**WATERTOWN
ROUTE 16 (MOUNT AUBURN STREET)**

POST DESIGN PUBLIC HEARING RENDERING
SHEET 1 OF 18

DESIGN RECOMMENDATIONS FROM PUBLIC PARTICIPATION PROCESS

PROJECT FILE NO. 607777
POST DESIGN PUBLIC HEARING RENDERING
SHEET 13 OF 18

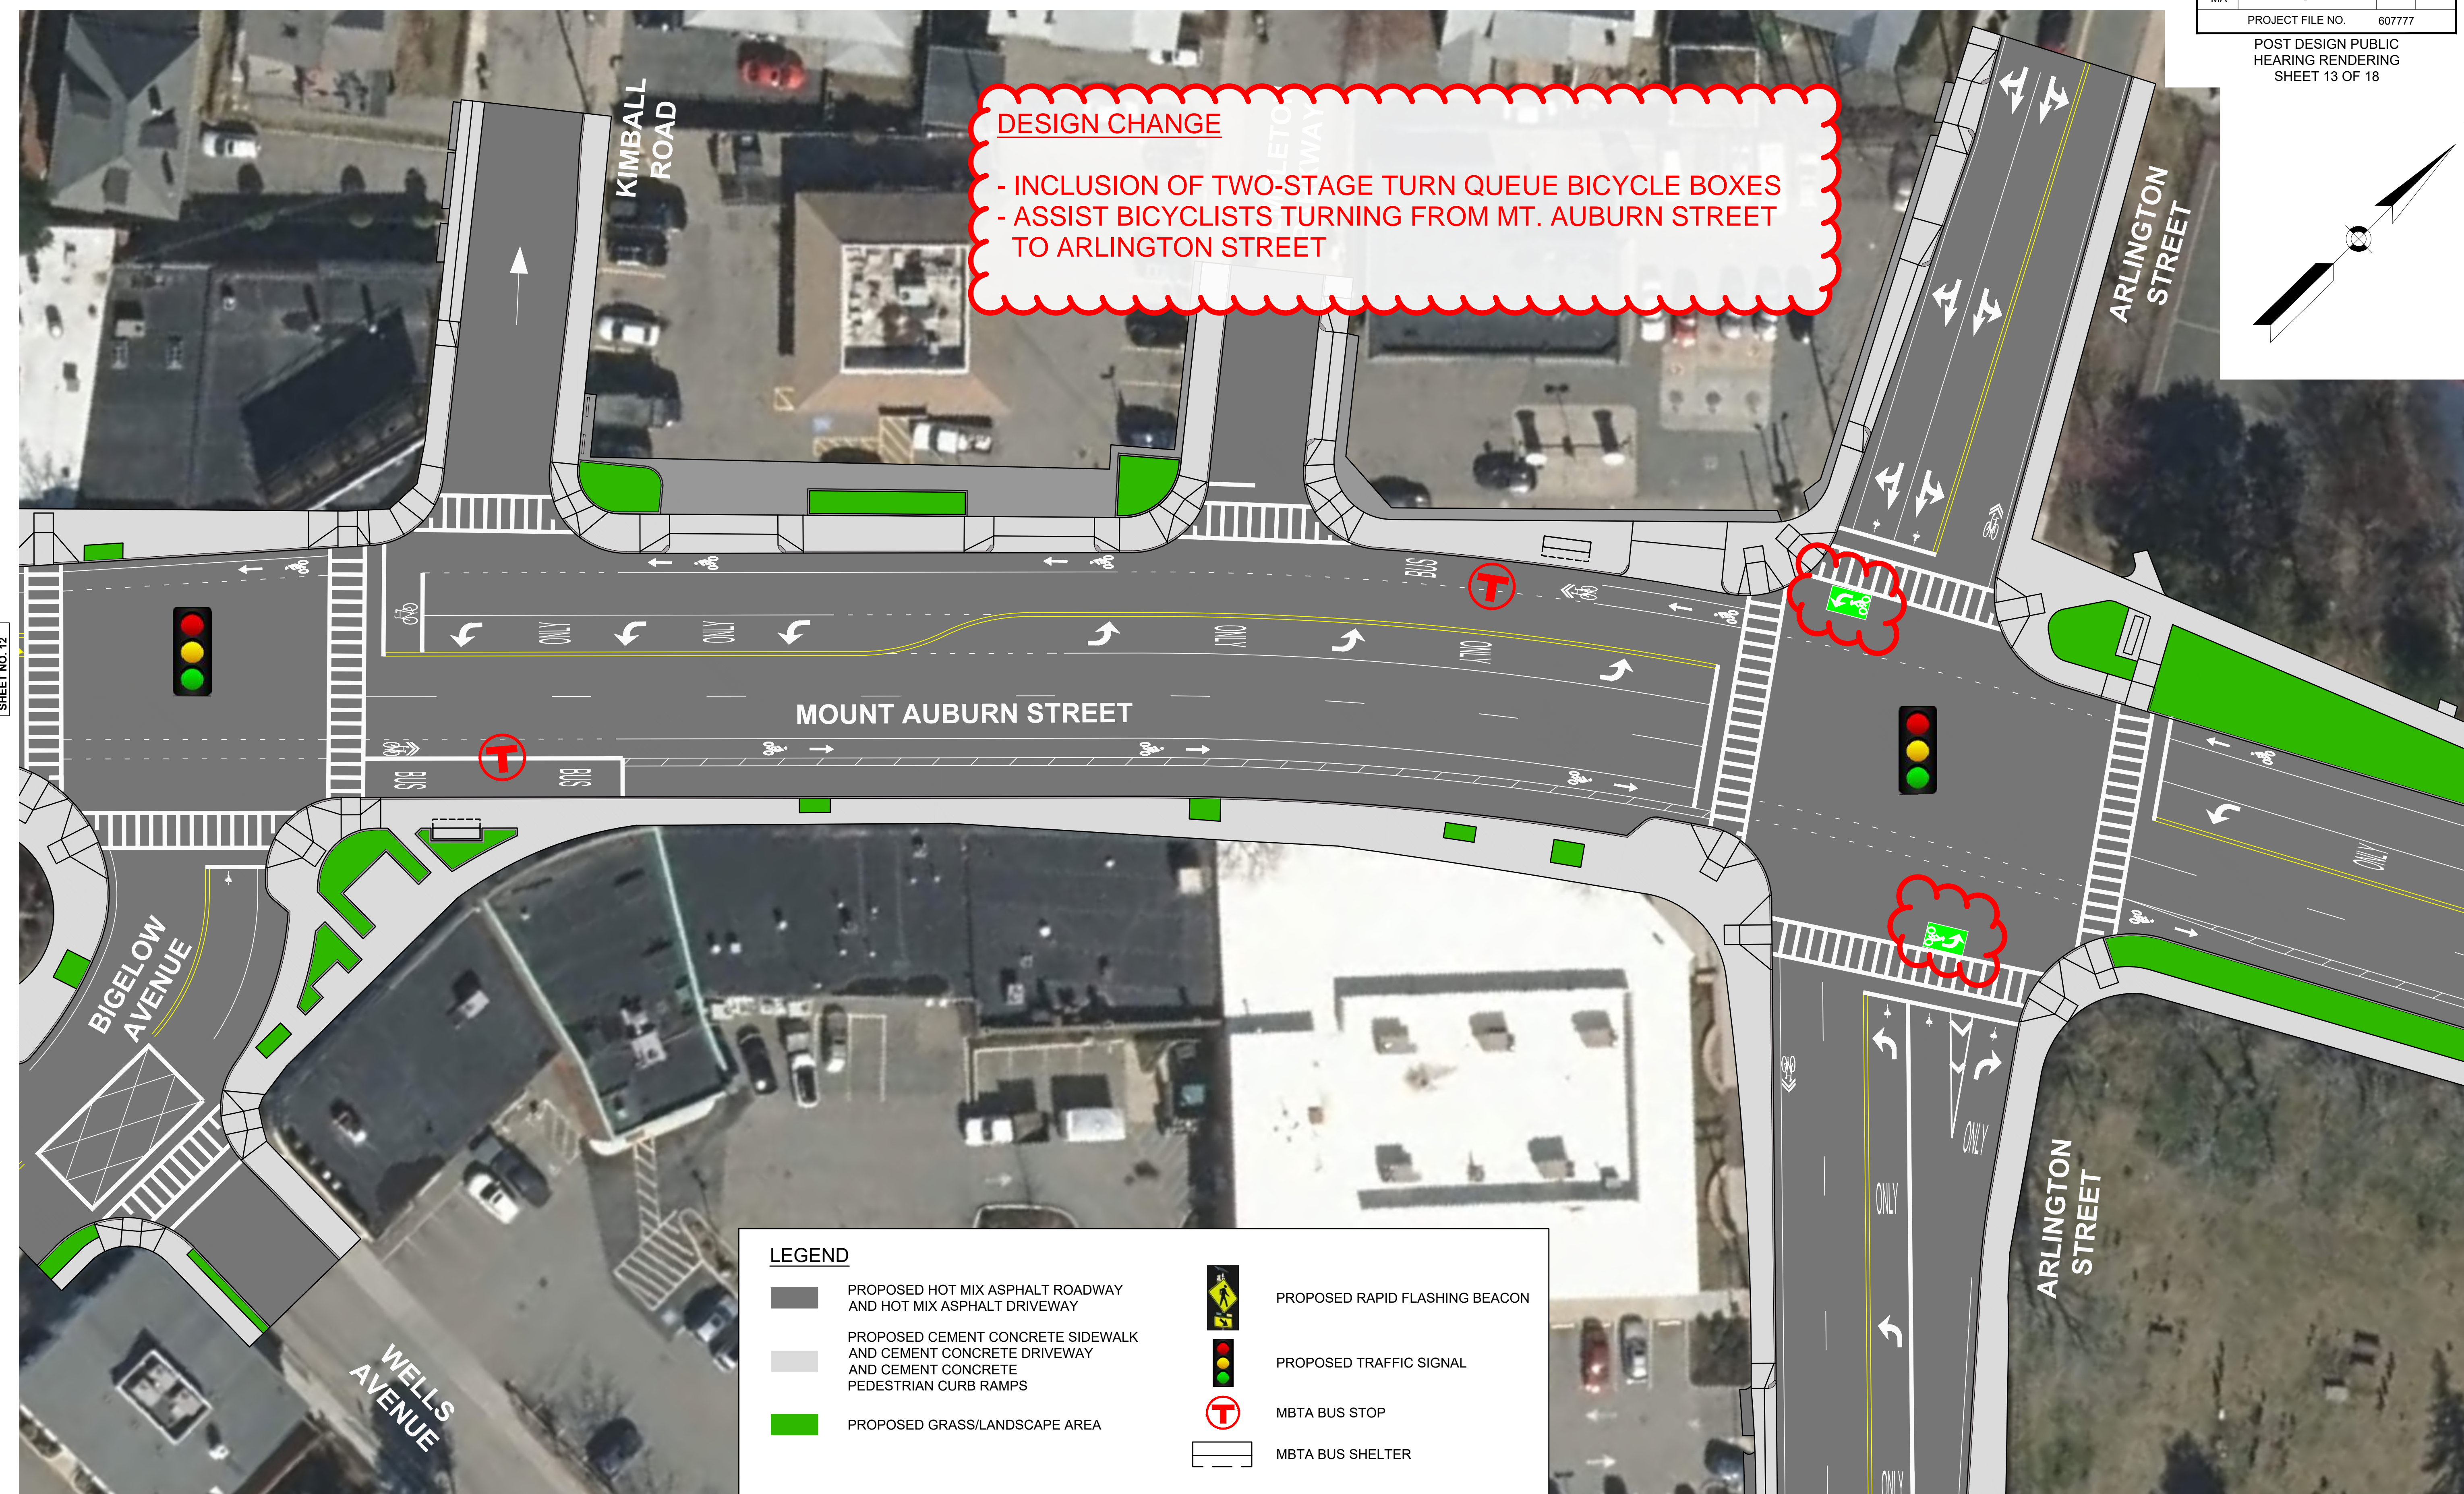
DESIGN CHANGE
- INCLUSION OF TWO-STAGE TURN QUEUE BICYCLE BOXES
- ASSIST BICYCLISTS TURNING FROM MT. AUBURN STREET TO ARLINGTON STREET

PROJECT FILE NO. 607777
POST DESIGN PUBLIC HEARING RENDERING
SHEET 14 OF 18

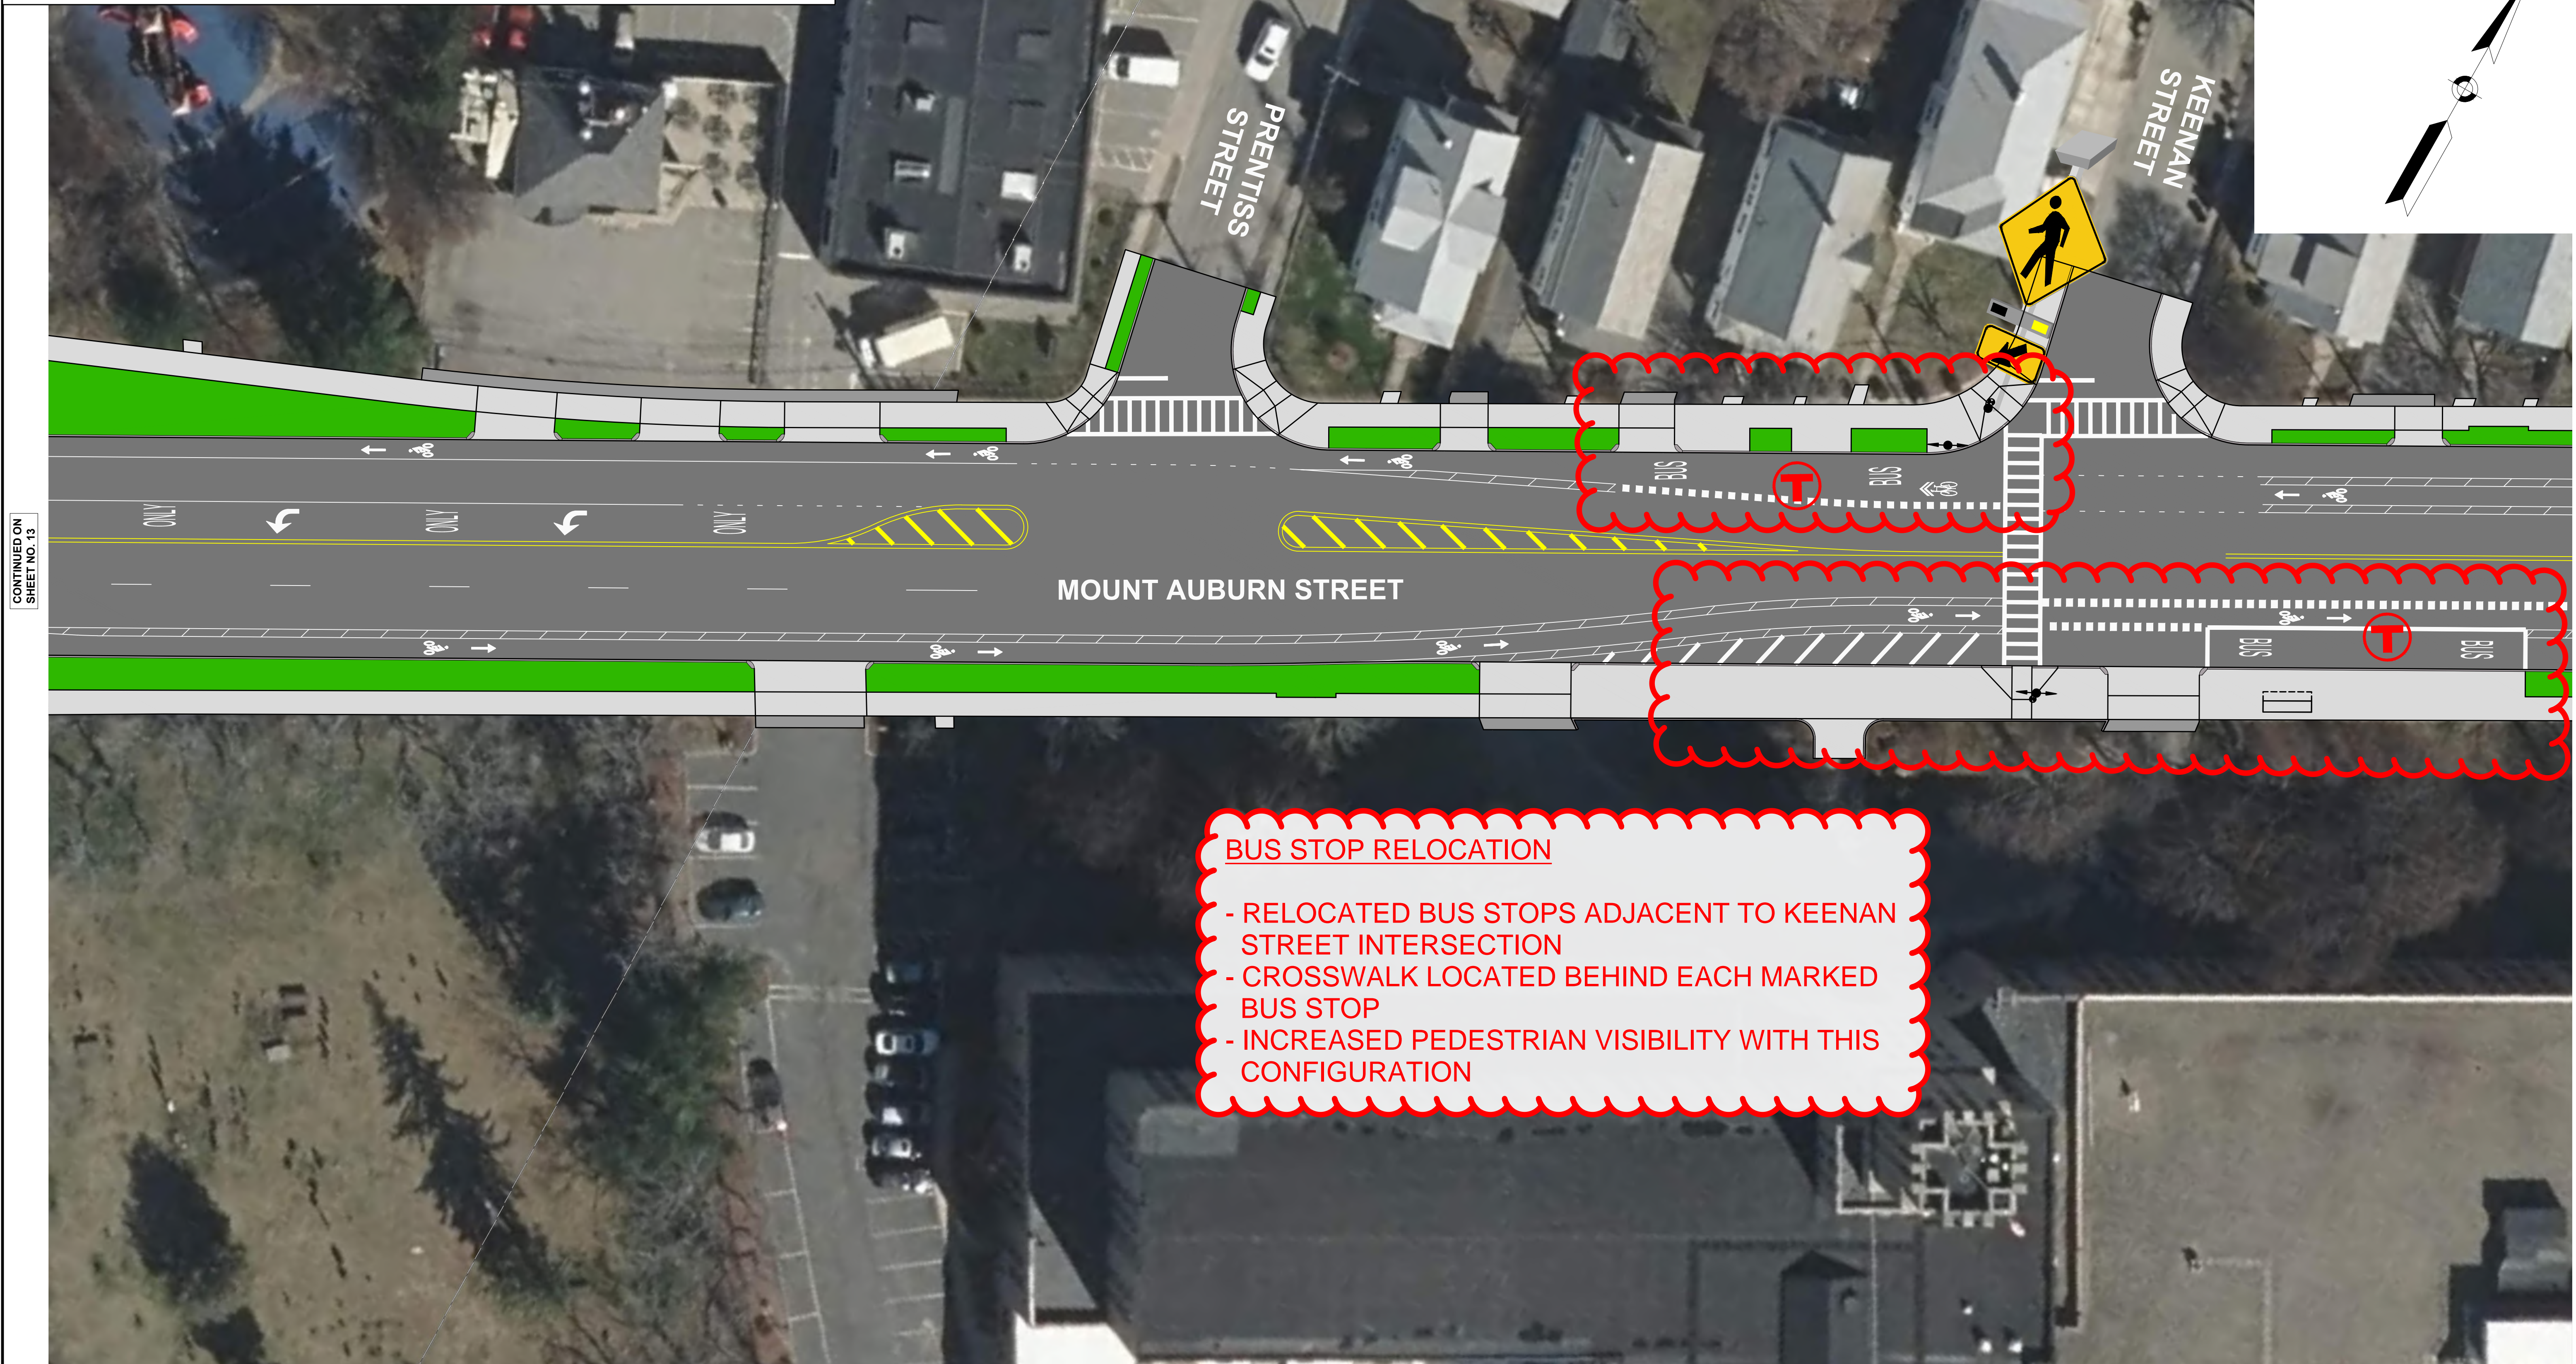
BUS STOP RELOCATION

- RELOCATED BUS STOPS ADJACENT TO KEENAN STREET INTERSECTION
- CROSSWALK LOCATED BEHIND EACH MARKED BUS STOP
- INCREASED PEDESTRIAN VISIBILITY WITH THIS CONFIGURATION

POST DESIGN PUBLIC HEARING RENDERING
SHEET 18 OF 18

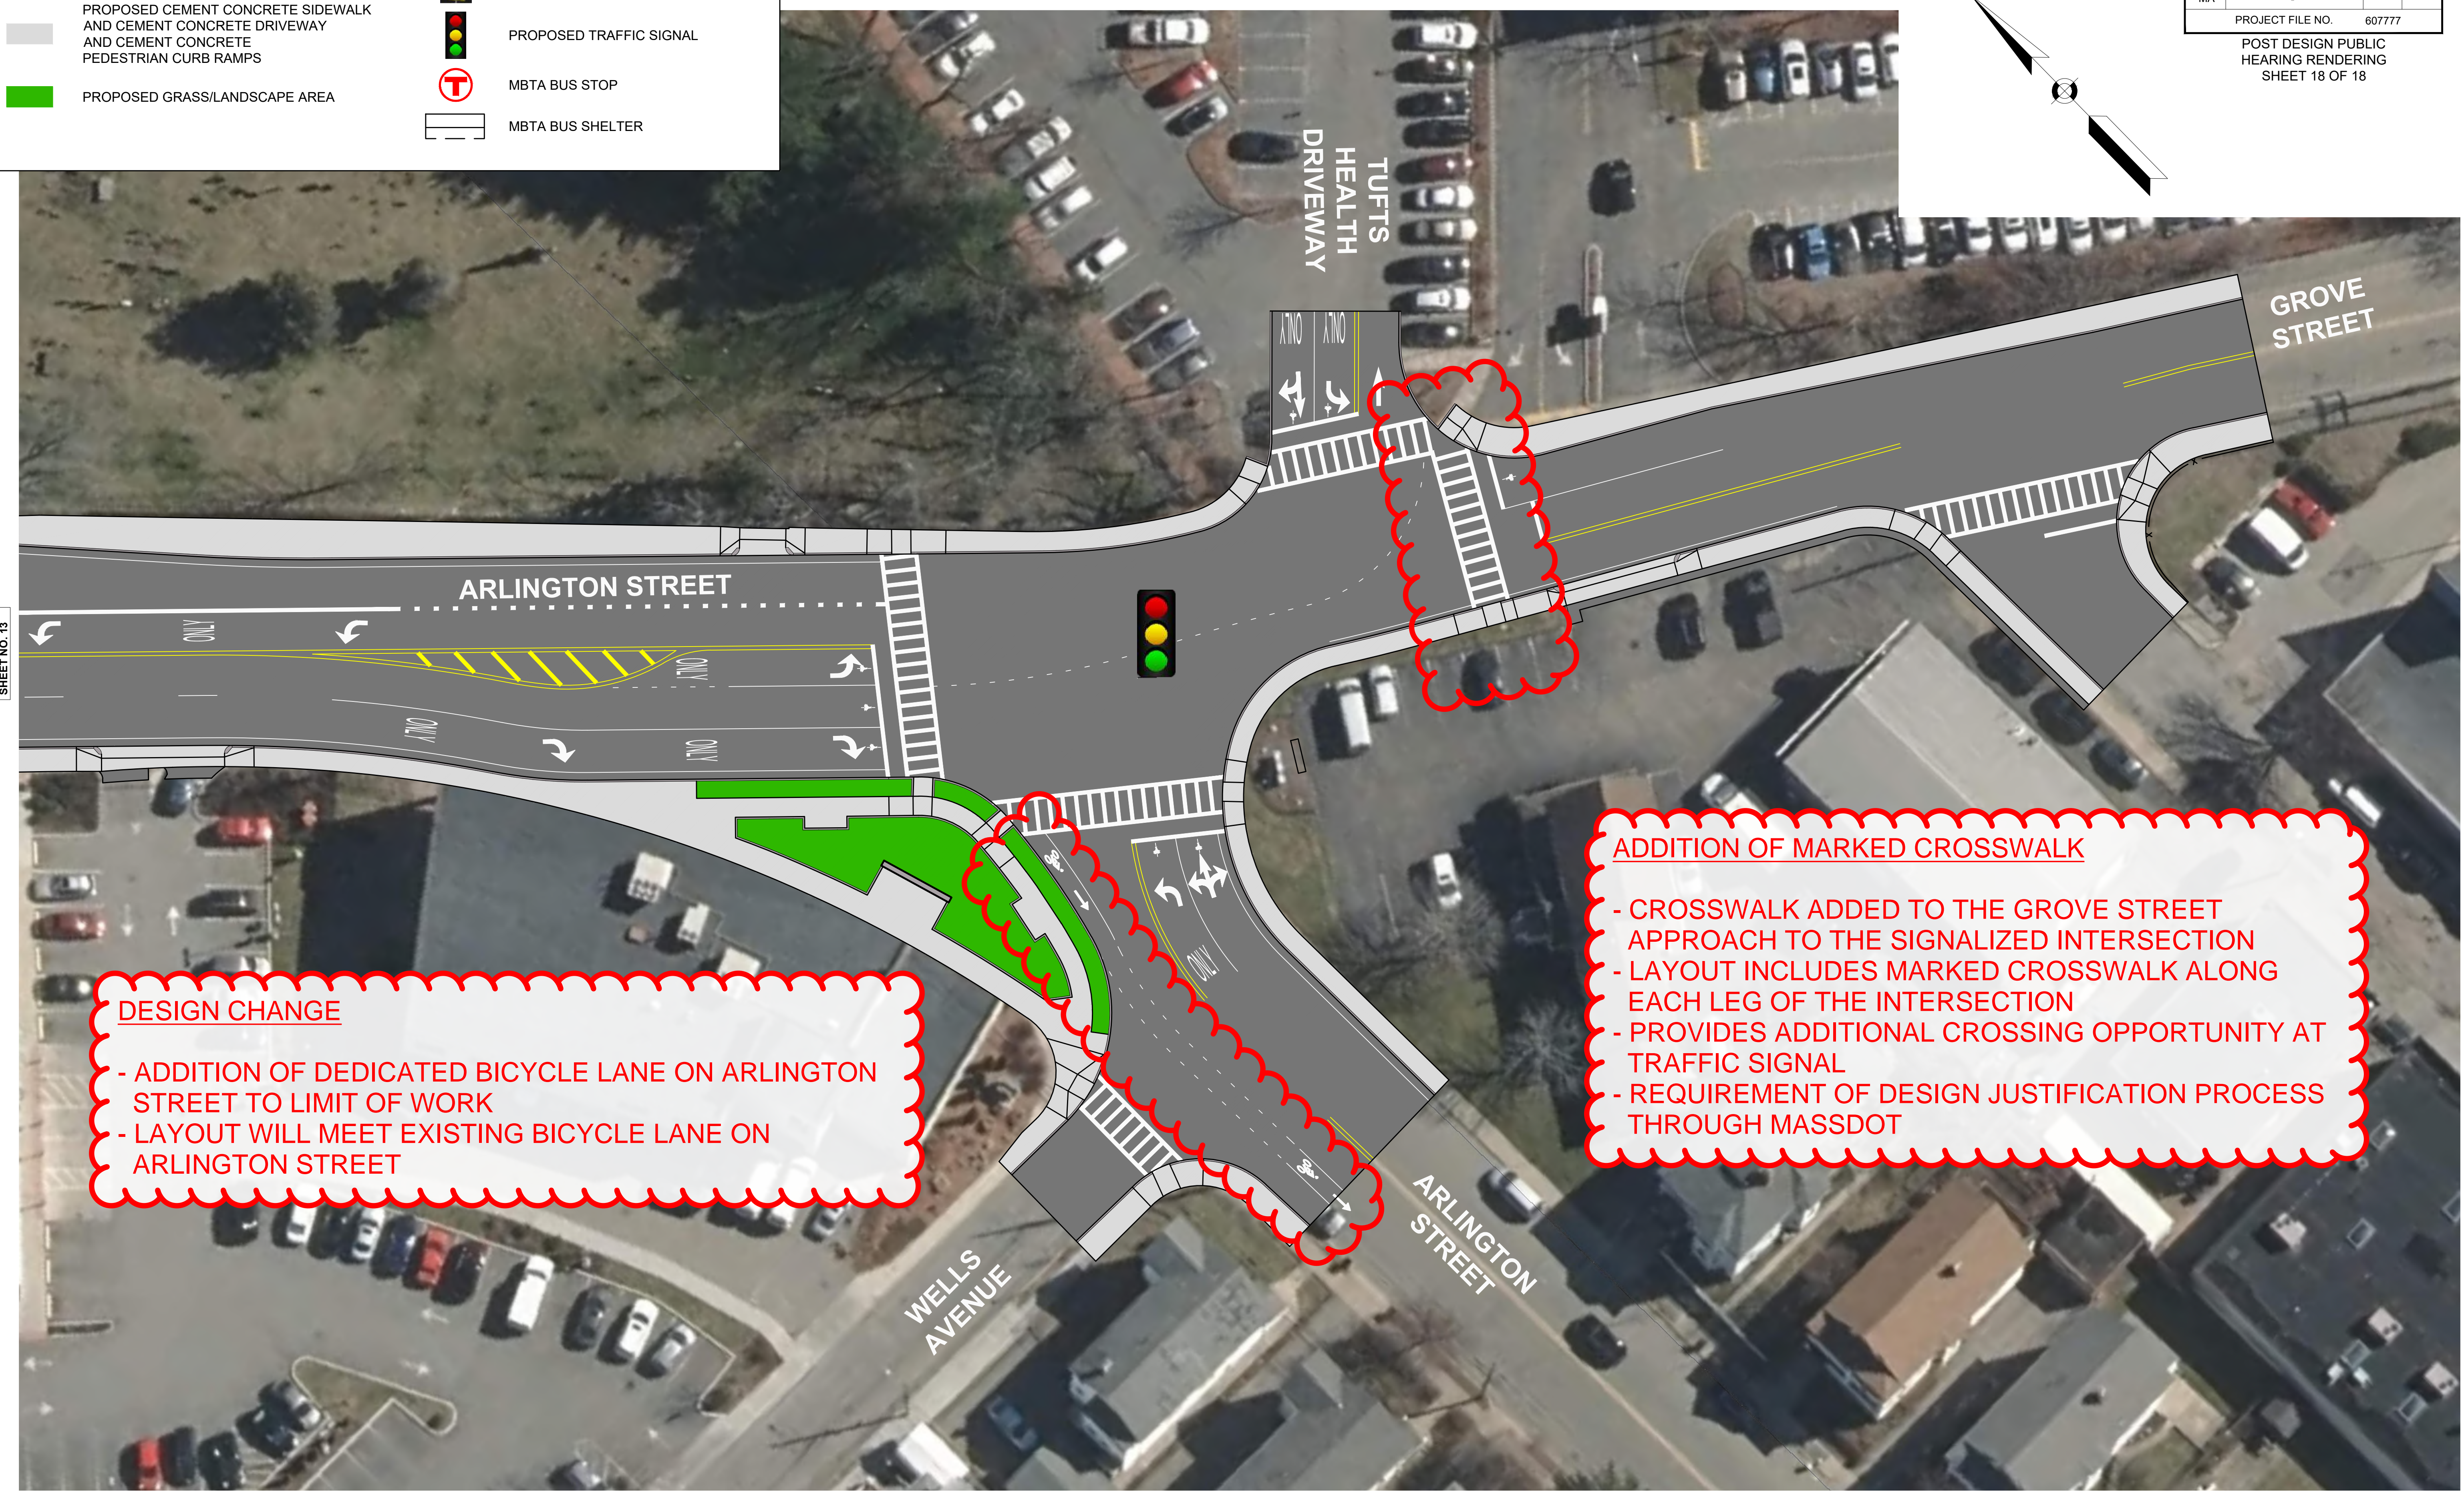
DESIGN CHANGE

- ADDITION OF DEDICATED BICYCLE LANE ON ARLINGTON STREET TO LIMIT OF WORK
- LAYOUT WILL MEET EXISTING BICYCLE LANE ON ARLINGTON STREET

ADDITION OF MARKED CROSSWALK

- CROSSWALK ADDED TO THE GROVE STREET APPROACH TO THE SIGNALIZED INTERSECTION
- LAYOUT INCLUDES MARKED CROSSWALK ALONG EACH LEG OF THE INTERSECTION
- PROVIDES ADDITIONAL CROSSING OPPORTUNITY AT TRAFFIC SIGNAL
- REQUIREMENT OF DESIGN JUSTIFICATION PROCESS THROUGH MASSDOT
